Determination 2023-012

Regarding the decision to issue a code compliance certificate for alterations to an existing dwelling

58 Moncks Spur Road, Redcliffs, Christchurch

Figure 2: Excavation to west side of ensuite extension³¹

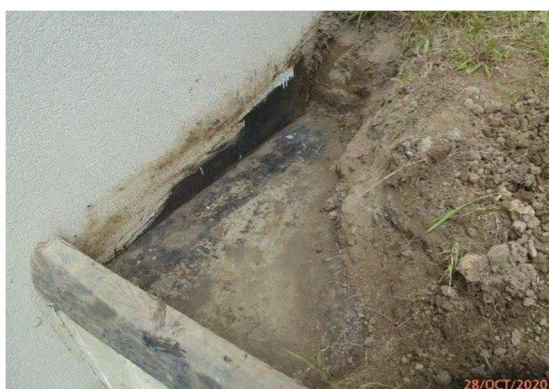
- 6.20. The builder’s submission is clear that no drainage coil was installed, and the expert confirmed that to be the case at the west side of the ensuite extension (see figure 2).

- 6.22. The expert’s observations confirm the sloping concrete surface was not constructed in the area excavated on the west side of the extension (refer to figure 2). Further, the extent of the liquid applied tanking membrane shown on the as-built plan provided by the builder was also not evident on the west side.

Note: No drainage coil has been installed, the horizontal concrete surface is level, and the 200mm strip of liquid applied tanking is exposed. No protection provided to the tanking.

Figure 4: Extract from plan “Block Wall Design” S-01 (not to scale)

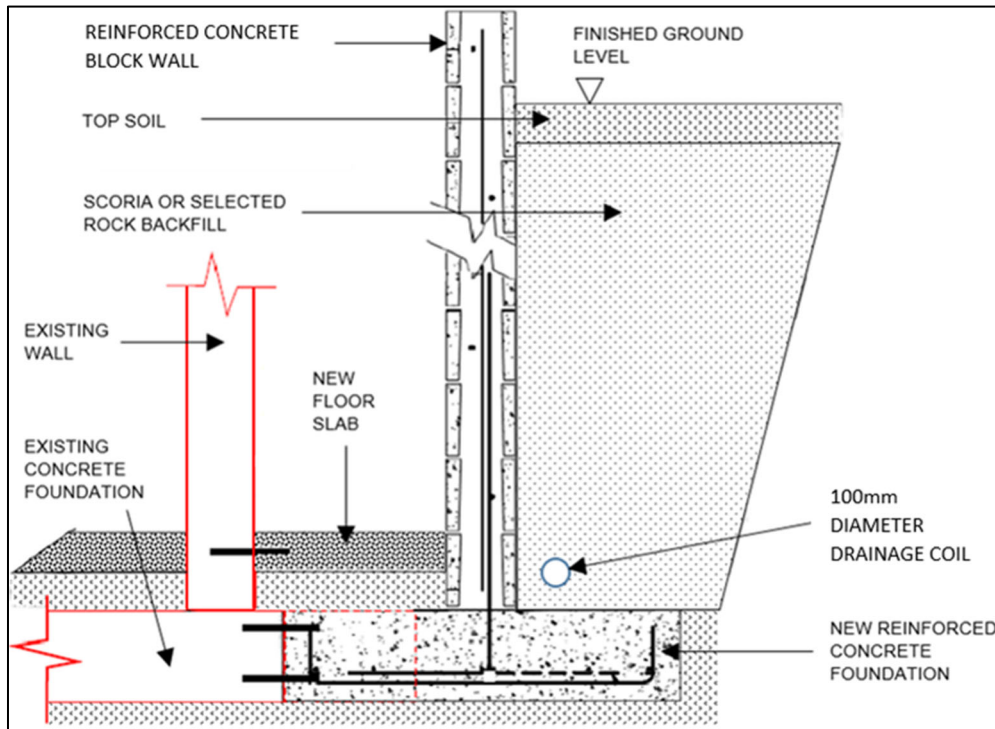
However, a drainage coil is shown on the engineer's specific engineering design drawing²⁵ that was included in the approved building consent plans (refer to Appendix A, figure 4).

The corresponding "new block wall plan" does not correctly cross-reference to this detail; it refers to the detail being on plan sheet S-02 when it is on plan sheet S-01.

- 6.19. The building consent plan sheet²⁹ shows a 100mm diameter drainage coil to the west side of the ensuite extension (see Appendix A, figure 4). It is not clear from the building consent plans whether the drain coil was intended also run across the south side of the ensuite extension foundation wall.

Figure 5: “As built” plan (not to scale)

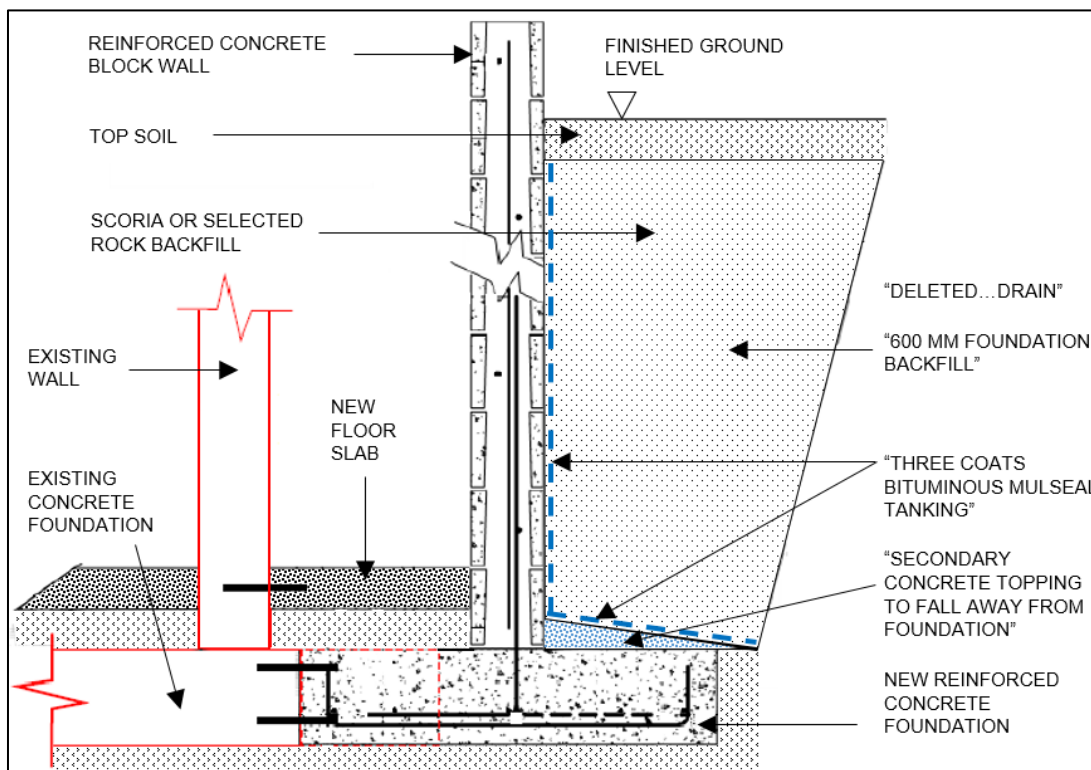
The expert confirmed there was no drainage coil found, and no sloping concrete topper at the toe of the foundation as shown in the as-built drawing. The expert stated that, regardless of the "as-built" information provided by the builder, the concrete surface adjacent to the foundation wall has been laid flat and there is no provision for any water to be drained away from the wall.

- 6.21. The builder submits that the revised detail that omitted the drainage coil (Appendix A, figure 5) was discussed with the authority’s inspector on site. The builder provided an “as built” plan to the authority on 16 August 2018. This was after the final inspection by the authority on 10 August 2018 but before the code compliance certificate was issued on 19 September 2018. The as-built plan indicates the drainage coil was not installed and it was replaced by a sloping concrete surface at the toe of the foundation (the “concrete topper”) and the application of a liquid applied tanking membrane to both the west and south sides of the ensuite extension (refer to Appendix A, figure 5).

- 6.23. Regarding the drainage coil, the “concrete topper” and the tanking membrane, it is clear that the building work was not completed in accordance with the plans submitted with the building consent application, nor is the work in accordance with the as-built plans provided to the authority. Therefore, I am of the view that the building work was not been completed in accordance with the building consent and the test under section 94(1)(a) of the Act has not been met.
